UNITED STATES ENVIRONMENTAL PROTECTION AGENCY

Re: November 12, 2019 Draft Final Remedial Investigation and Feasibility Study Work Plan, West Lake Landfill, Operable Unit 3

Comments to the November 12, 2019, Draft Final OU-3 Remedial Investigation/Feasibility Study Work Plan, Site Wide Groundwater (Operable Unit 03), West Lake Landfill Site, Bridgeton, Missouri.

Figure A Topographic Ridge Hydrologic Boundary - Approximate location of currently defined model domain boundary, revised location of model domain boundary at natural flow boundaries, and location of needed additional model water-level calibration points.

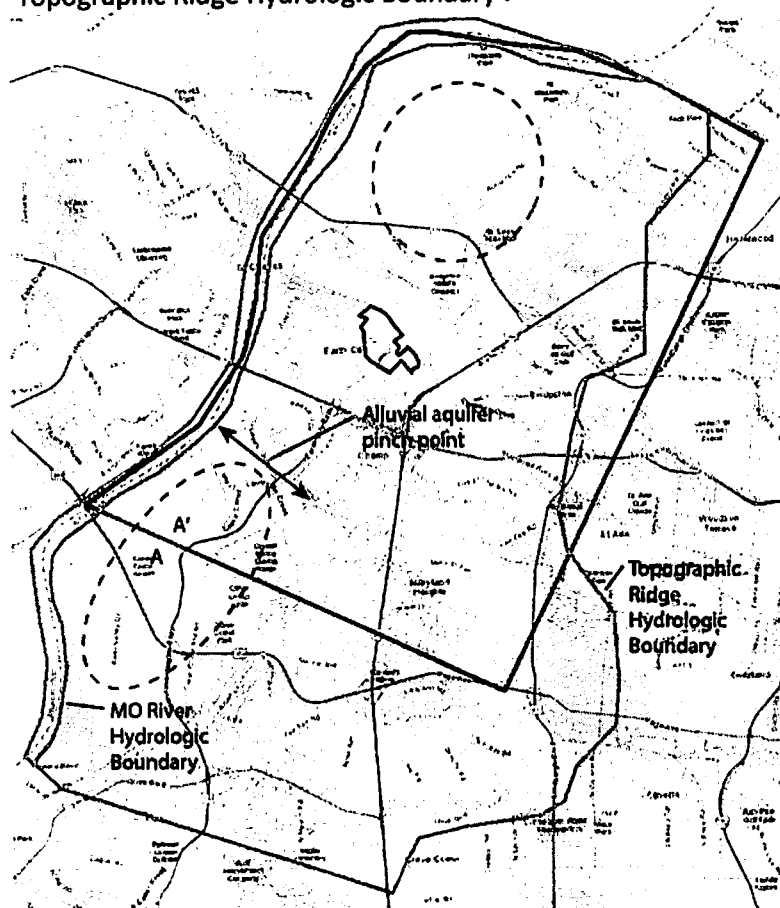
Neither the proposed new monitoring wells or the existing monitoring wells are sufficiently spatially distributed within the model domain to allow for confidence in the model calibration, particularly further away from the site. Because of the relatively small area of calibration points currently defined in the work plan, even relatively small errors in model fit at and near the site would likely translate to much larger errors and larger predictive uncertainty at the terminus of predicted alluvial flow paths associated with the site. Revise the work plan to include additional water-level measurement points in the areas as shown on Figure A (see the dashed oval areas on Figure A, below) to allow for proper model calibration across the model domain. Water-level data must include measurements collected in these areas throughout the duration of the RI in both new and existing wells.

Revise the proposed location for the model domain boundary in the Work Plan and Figure 3-16 to intersect with a natural flow boundary. The proposed upstream (southerly) model domain boundary (figure A; at label A-A') is not located at a natural flow boundary. Head information is required on

both sides of this boundary (measured concurrently through time) to adequately define the transient flux across the model boundary. The proposed new alluvial monitoring wells are located over 2 miles downstream of this apparent boundary location and will not be adequate for defining transient conditions at this boundary. Additionally, there is an area where the lateral extent of the alluvial aquifer narrows (see Figure A item labeled 'pinch point') that is anticipated to have an effect on the hydraulic gradient in this area. To simplify this boundary condition and lessen potential impacts of inadequately defining the flux and head distribution across this boundary, revise the model boundary by moving it further south-southwest to the Missouri River (orange line; see Figure A). Further, the proposed upland model domain boundary (to the southeast) is not defined at a natural flow boundary. Revise Figure 3-16 to move this domain boundary to the natural flow boundary at the topographic high on the ridge to the southeast. See Figure A (below) labeled 'Topographic Ridge Hydrologic Boundary'.
